**WHEELING PLAN COMMISSION
THURSDAY, JUNE 28, 2018 6:30 P.M.**

**AGENDA FOR A REGULAR MEETING OF THE PLAN COMMISSION
Board Room - 2 Community Boulevard, Wheeling, Illinois**

REQUEST FOR PLAN COMMISSION ACTION
STAFF PROJECT REVIEW

RE: **Docket No. SCBA 18-9**
The Whitley of Wheeling
156 W. Dundee Road
Appearance Approval of a Freestanding Sign

5 MONUMENT SIGN COLOR EAST ELEVATION
SCALE: 1/2"=1'-0"

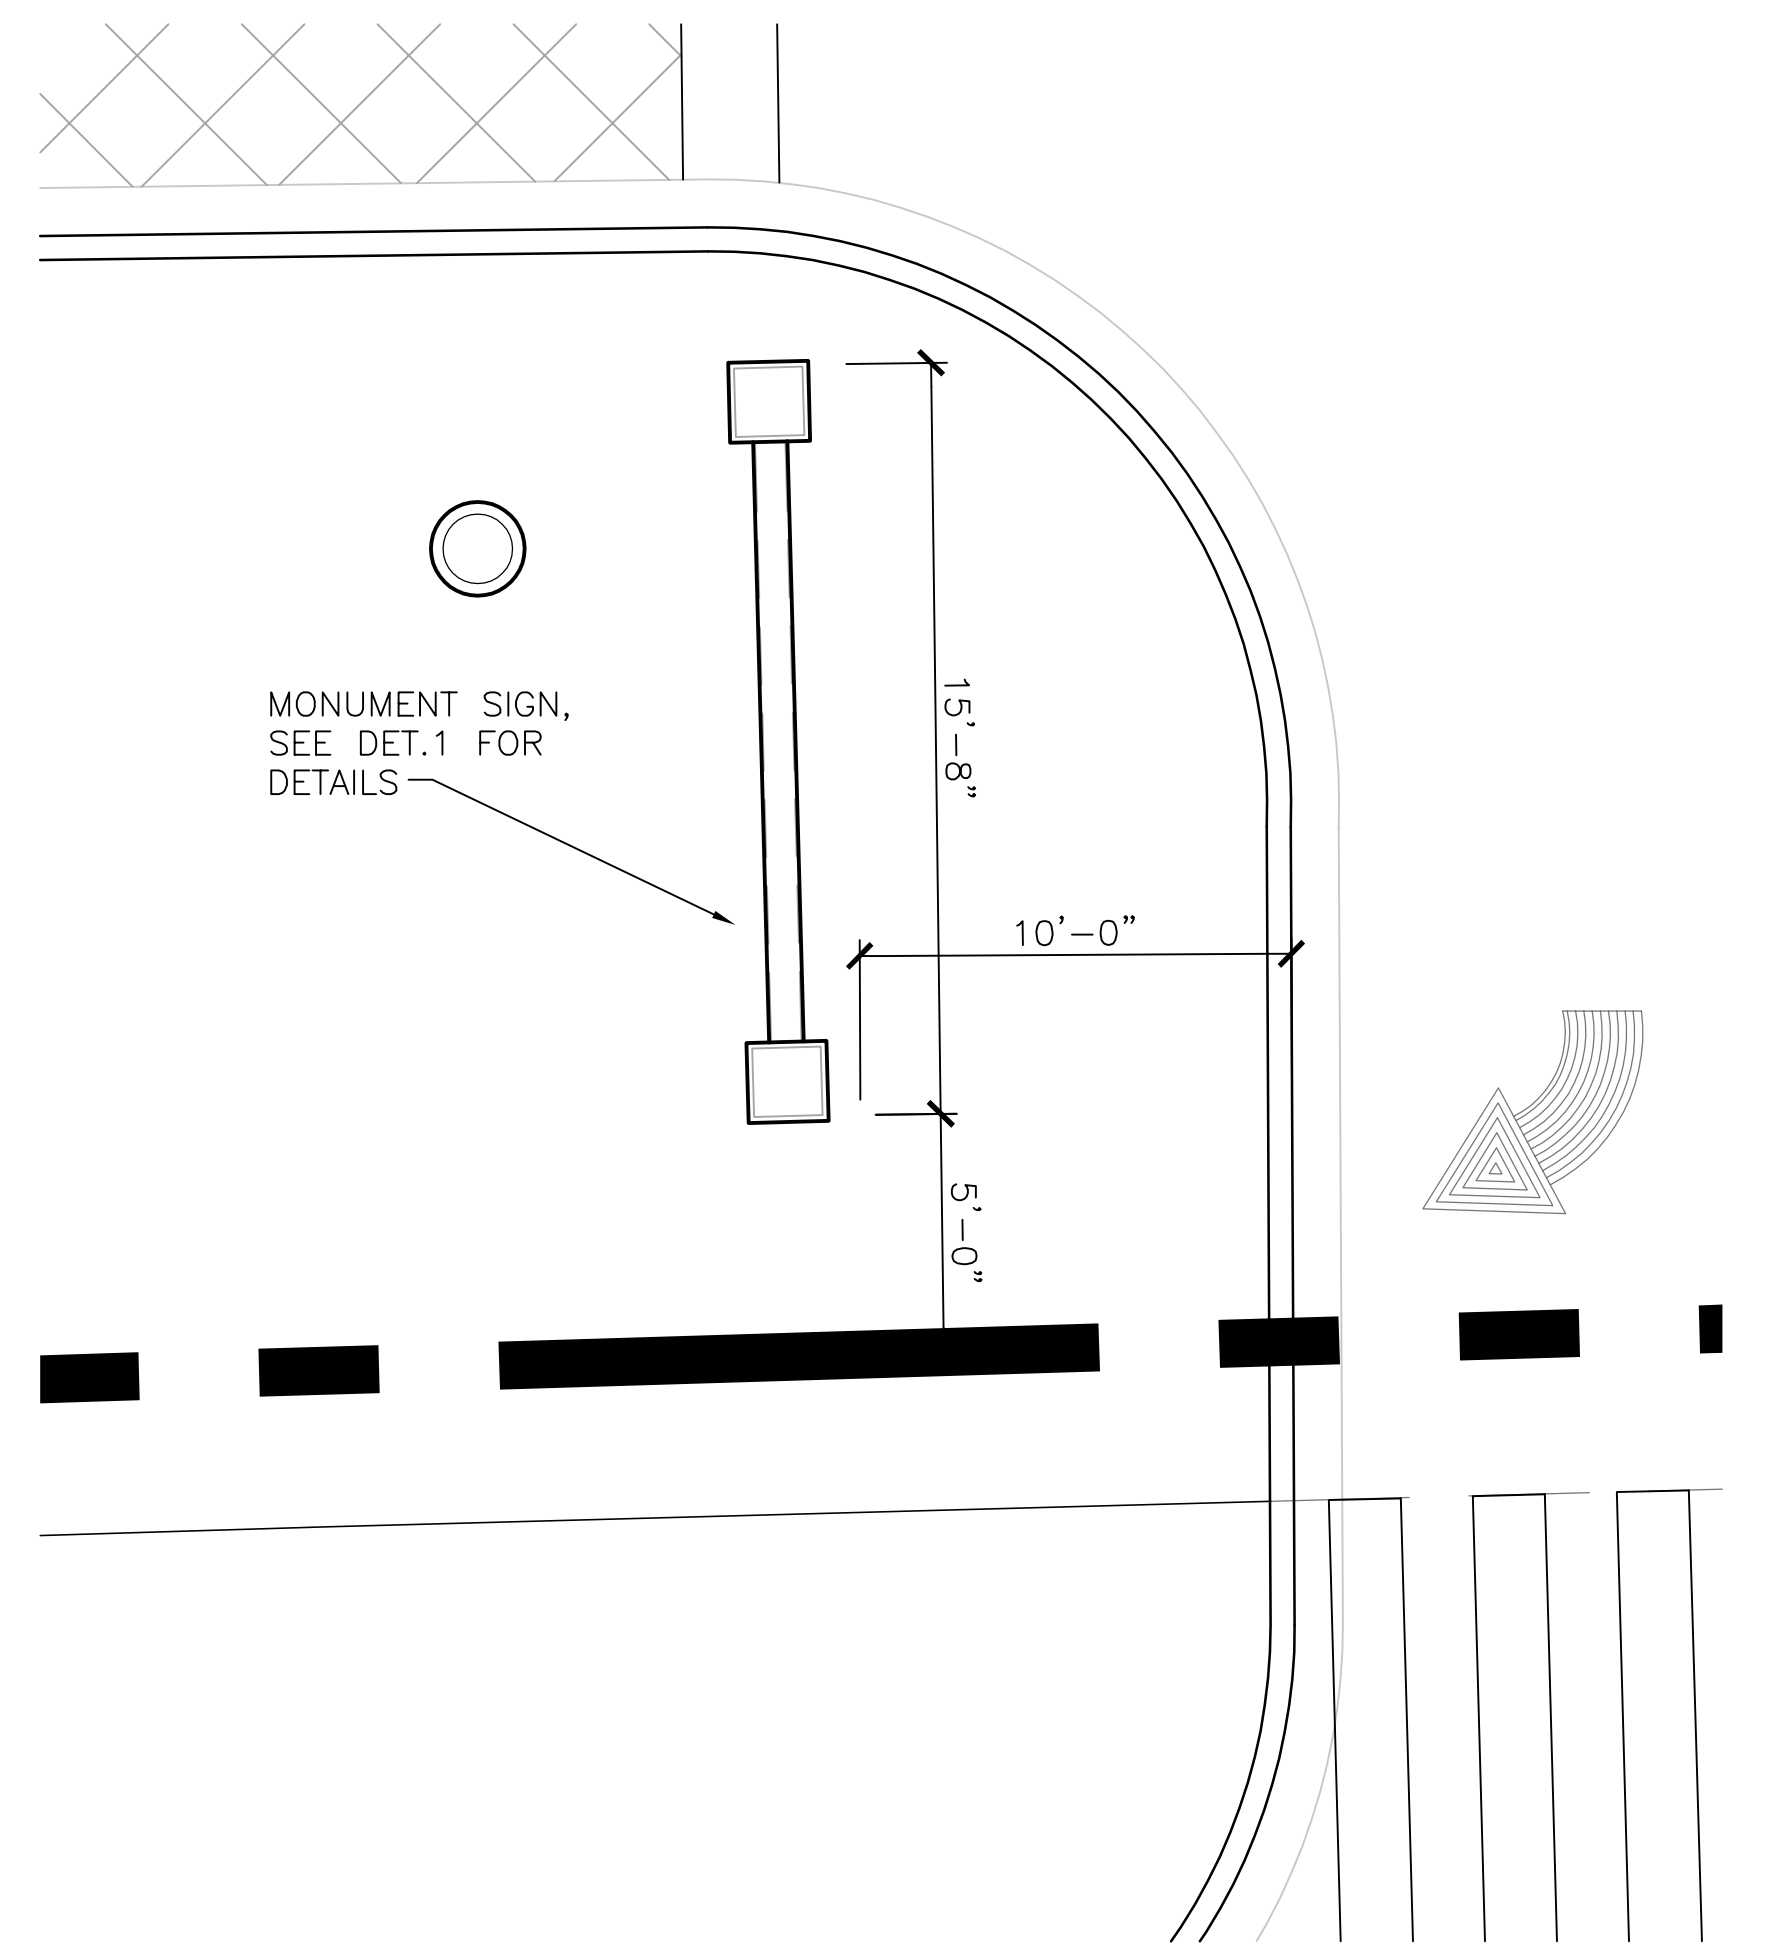
Landscaping: A landscape plan is proposed for the freestanding sign. The proposed landscaped area is approximately 265 square feet, which is one and half times the size of the required landscaped area. The proposed landscape plan meets the species mix requirements of the Sign Code. It includes dwarf evergreens (Broadmoor Juniper), winter interest (Evergold Japanese Sedge), deciduous shrubs (Annabelle Hydrangea), and flowering annual flowers. The landscape plan also notes that it will be irrigated.

Approve Docket No. SCBA 18-9 to grant appearance approval for the freestanding sign in accordance with the sign, landscaping, and lighting plans (8 sheets) submitted May 30, 2018 by SAS Architects, on behalf of The Whitley, located at 156 W. Dundee Road, Wheeling, Illinois.

SITE PLAN

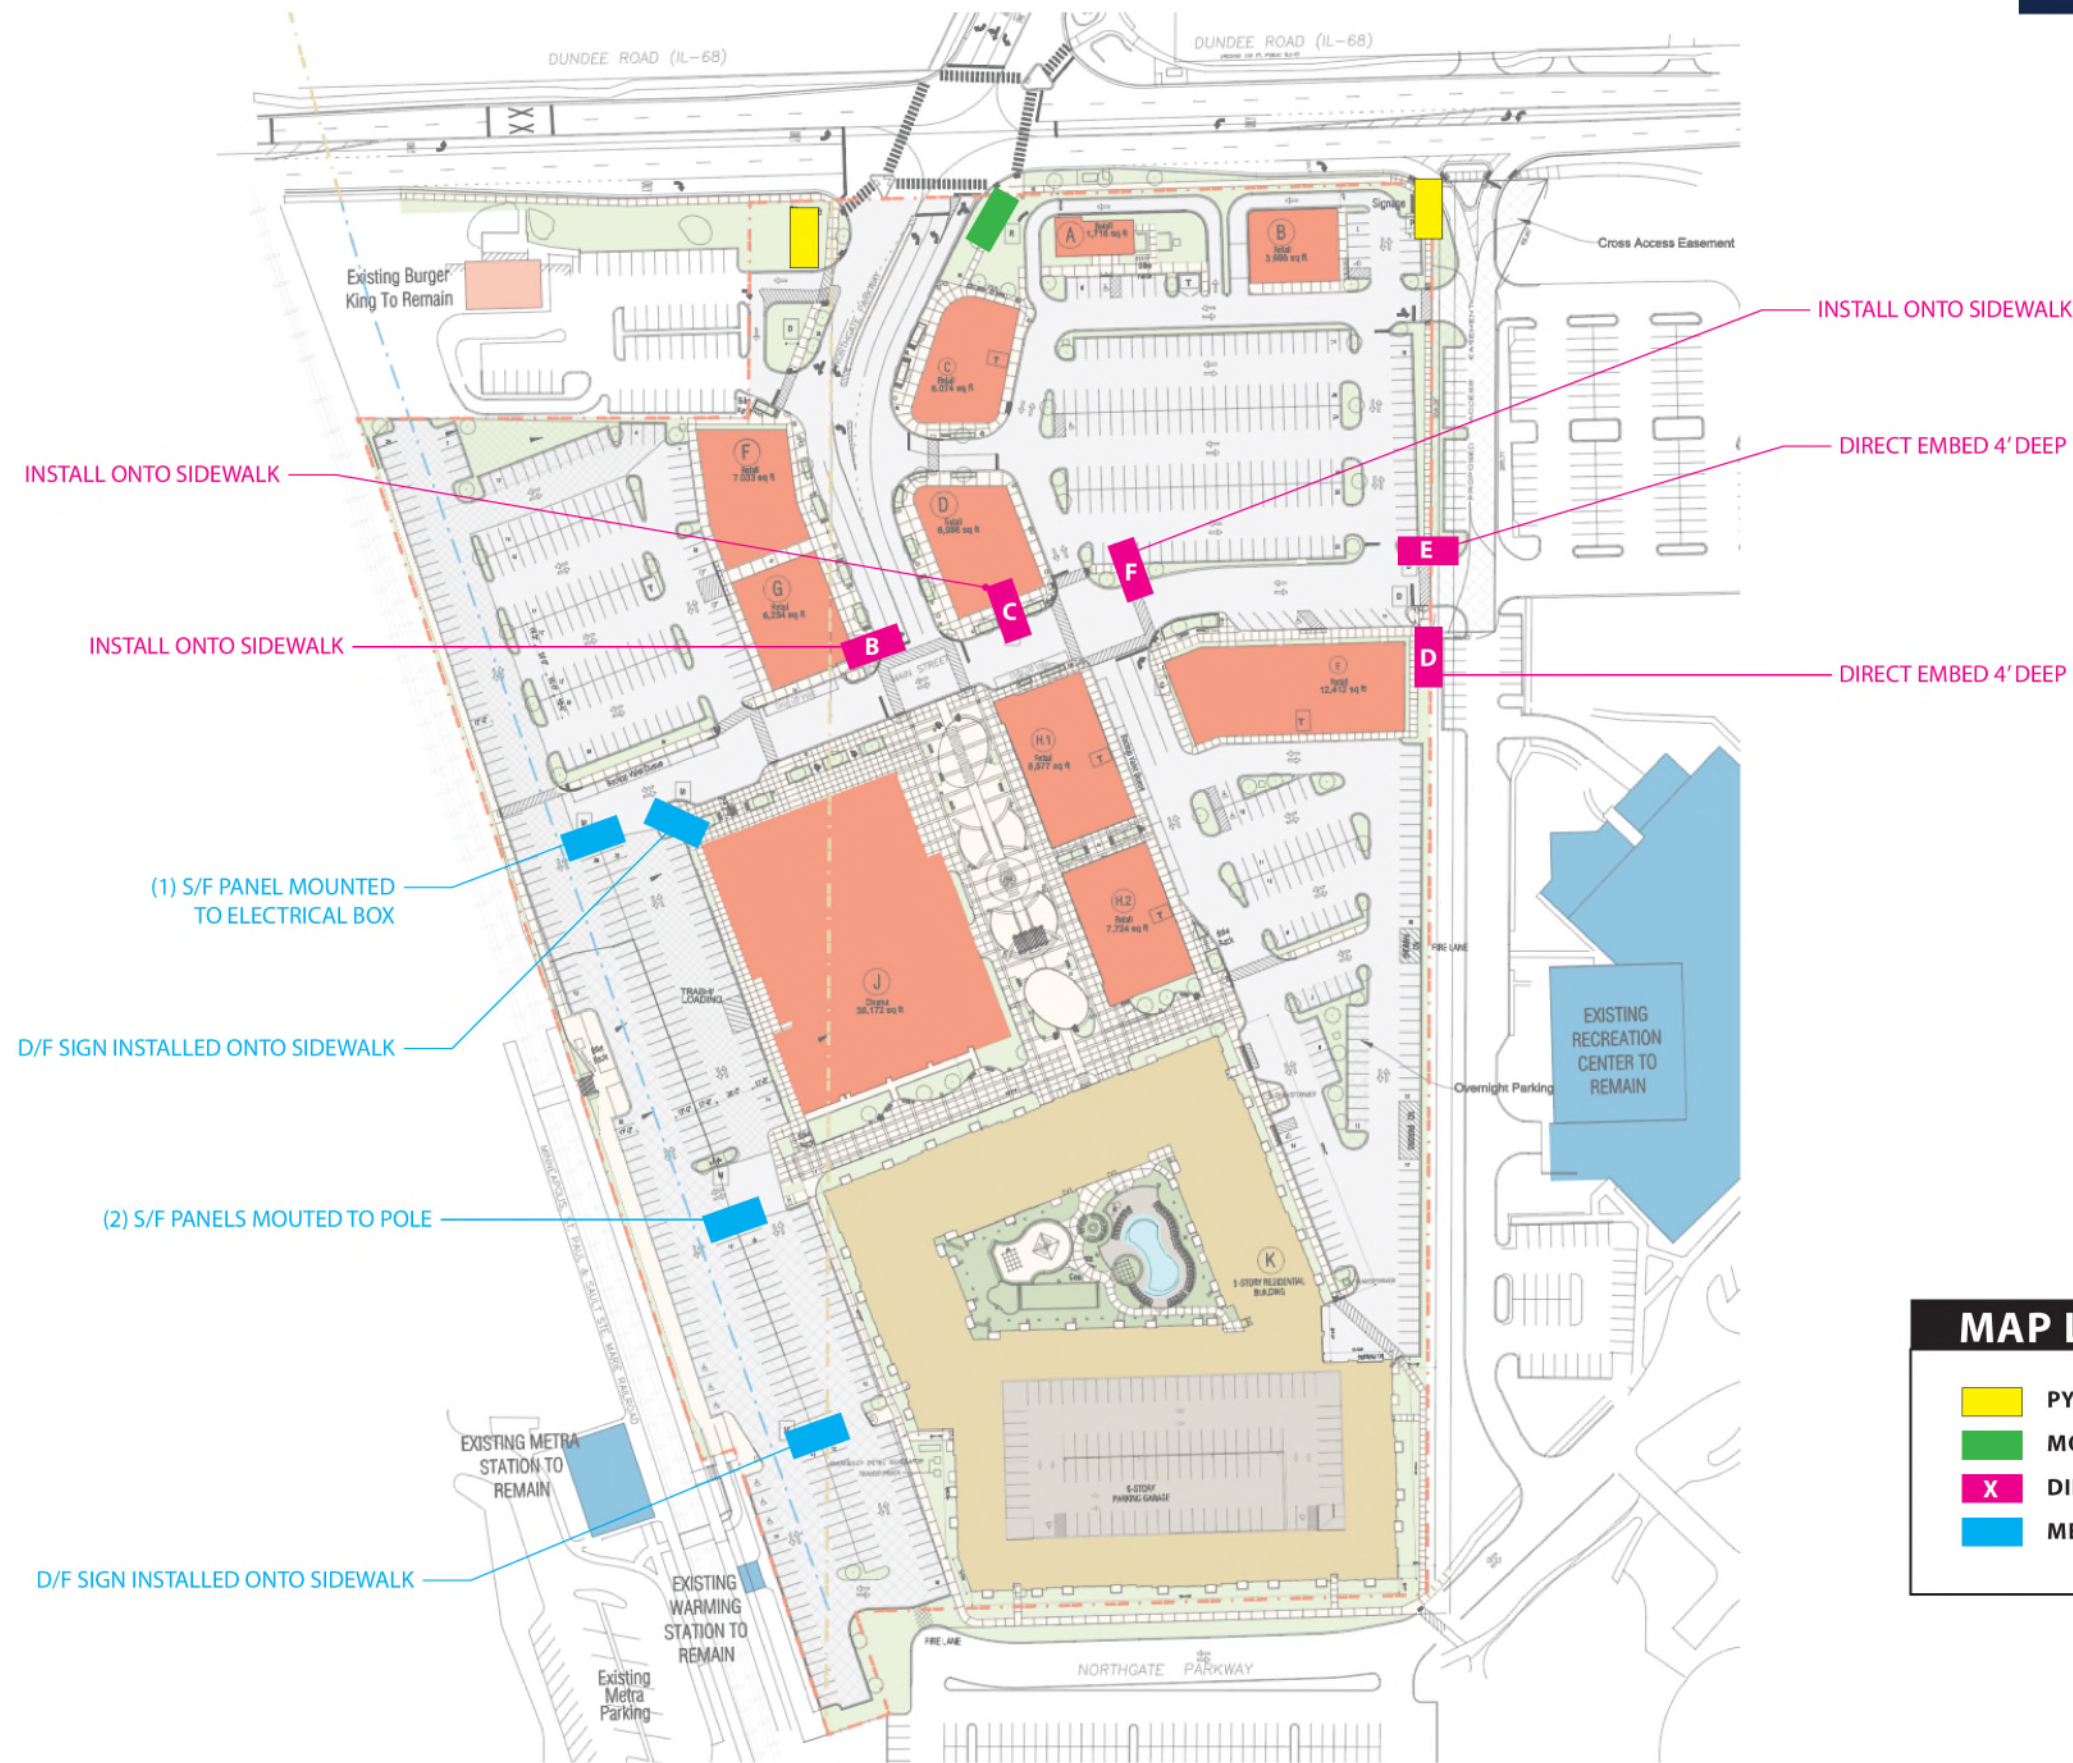
Sign Locations: Two multi-tenant directory signs are proposed along Dundee Road. One is located at the southwest corner of Dundee and Northgate Parkway. The other is located at the southwest corner of Dundee and the right-in, right-out access drive east of building B. Each sign is perpendicular to Dundee Road. Per Code, a ten-foot minimum setback is required. No change is proposed to the sign locations since they were reviewed earlier this year. The locations of the proposed directional signs are shown on the overall site plan.

Two types of directional signs are also proposed for inside the Town Center development. First, is the Wheeling Town Center directional signs. Five such signs are proposed. The site plan illustrates the exact locations in the development. The signs are 6'8" high and include 13.3 sq. ft. of sign area. The signs are double-sided and appear of similar design to the multi-tenant signs, which include black aluminum cabinets with white lettering. The signs are non-illuminated. The second type of sign is the Metra parking directional sign. There are four such signs. The site plan illustrates the exact locations in the Metra parking lot. These double-sided non-illuminated pole signs are similar to other Metra parking signs in the region. They have a blue cabinet with white lettering. The signs are 12.7 square feet in size
